## **Response to Action Item 19-157 Section 19.1**

### **PRA Issue List Regarding APR-1400, DCD Tier 2, SECTION 19.1**

**Attachment – Section 19.1.5.3.2.1 DCD Markup for Question PRA-150**

Figure 19.1-49 CET Quantification Results for Internal Events

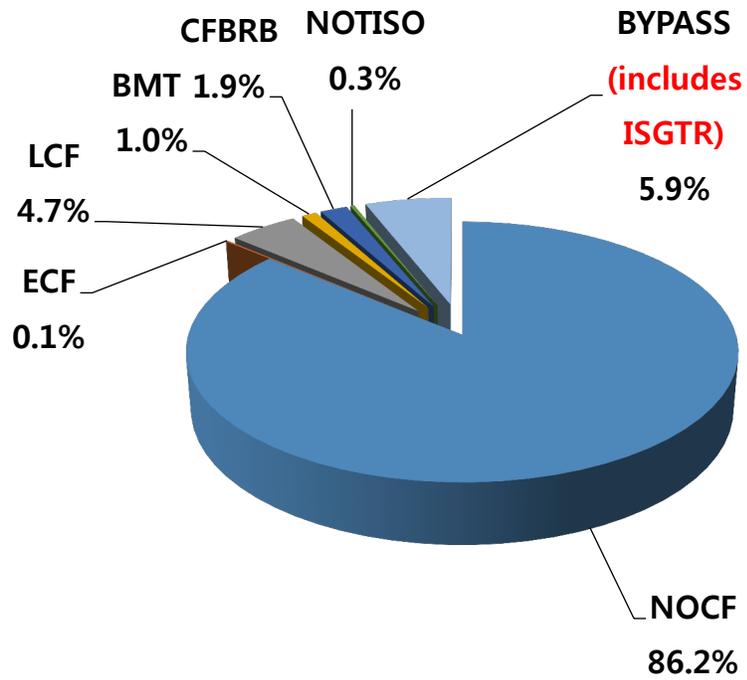
Containment event tree quantification results shown for internal events containment bypass on Figure 4-1 of APR1400-K-P-NR-013604-P, "APR1400 Design Certification Probabilistic Risk Assessment: Full Power Level 2 PRA: Quantification Notebook," Revision 0, July 2013, does not agree with the value provided in Figure 3-1. Using the values provided in Figure 3-1, the staff calculated a total frequency of containment bypass, which consists of PDS 1 through 4, to be  $6.43\text{E-}8$  /ry ( $2.41\text{E-}8 + 4.01\text{E-}8 + 1.18\text{E-}10 + 0.0\text{E+}00$  /ry). In contrast, Figure 4-1 shows frequency of containment bypass as  $7.75\text{E-}8$  /ry.

Both Figure 4-1 and DCD Figure 19.1-49 show a containment bypass frequency as 5.9% of CDF (DCD Figure 19.1-49 shows only percentage containment failure frequency values.).

PDS 1 and 2 are sequences with SGTR initiating events, and PDS 3 and 4 are ISLOCA sequences. All four are included to the Containment Bypass frequency shown in Figure 4-1 of APR1400-K-P-NR-013604-P and Figure 19.1-49 of the DCD. However, the Containment Bypass frequency in these figures also includes the severe accident- induced SGTR frequencies from PDSs 5 through 108.

Level 2 CET is a systematic calculation tool to quantify the containment bypass frequency including both sequences initiated by SGTR and induced SGTR sequences. The total bypass frequency of  $7.75\text{E-}08$  /ry is the quantification result including induced SGTR frequency from all the PDSs.

The DCD is revised to clarify the meanings, as shown in Attachment 1.
